Appendix H: Comments on Draft IGP Report

1 Comments on Draft IGP Report

Provided in this section is a compilation of comments received from the public, PUC staff and technical advisory panel in response to the Draft Integrated Grid Plan filed on March 31, 2023. We received comments through our website at, <https://hawaiipowered.com/igpreport/>, through public comments filed in Docket No. 2018-0165 and other comments through email. To notify the public of the Draft Integrated Grid Plan and invite submission of comments, we issued a press release on April 3, 2023 (available at, <https://www.hawaiielectric.com/hawaiian-electric-seeks-public-comment-on-draft-integrated-grid-plan-a-pathway-to-a-clean-energy-future>) inviting the public to submit comments through April 21, 2023. We promoted the issuance of the Integrated Grid Plan on social media, and local print and news media also ran stories inviting public comments to the report.¹

Figure 1-4:

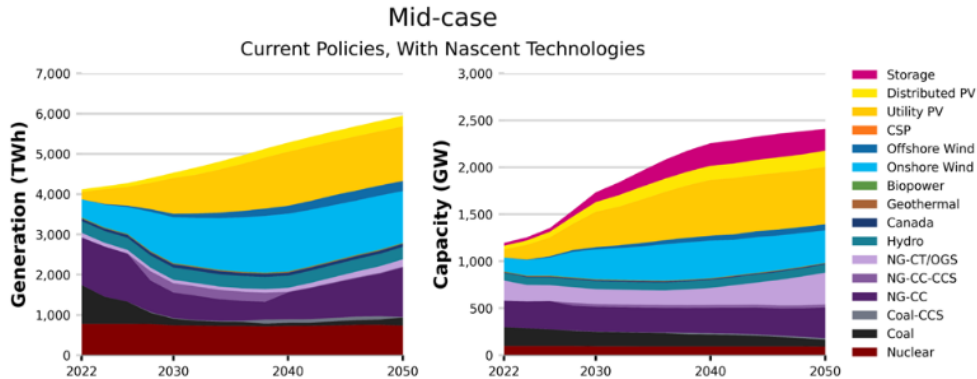
- The change in generation profile from 2022 to 2030 is enormous (from 32% renewable to 81%). How likely is it to be successful? How far do just Stage 1 and Stage 2 resources get you?
- Stacked area plots or stacked bar charts are easier to read than side-by-side pie/donut charts to show the preferred portfolio resource mix over time. (Figure 2-3, etc.) Here is an example of stacked area plots from NREL's Standard Scenarios report:

Hawaiian Electric Response – Stacked area versions of the pie charts have been inserted into the Preferred Plan subsections in Section 8.

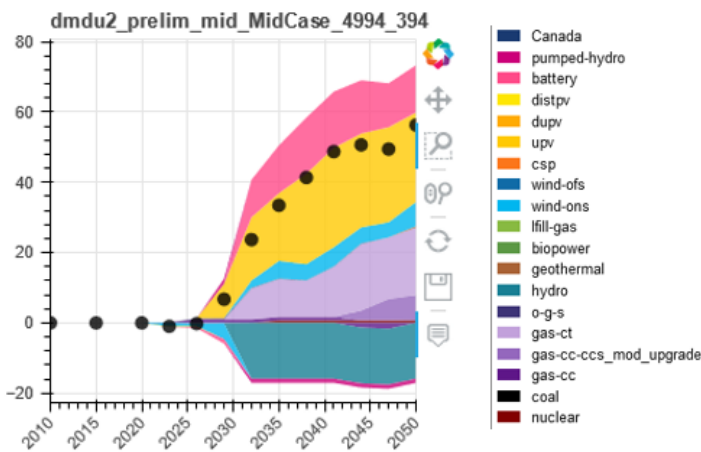
- It would be good to provide an installed capacity version of the same information early on (e.g. Section 2) – especially if the plots later in Section 8 don't reflect the final preferred plans

Hawaiian Electric Response – Installed Capacity Stacked area charts have been inserted into the Preferred Plan subsections in Section 8.
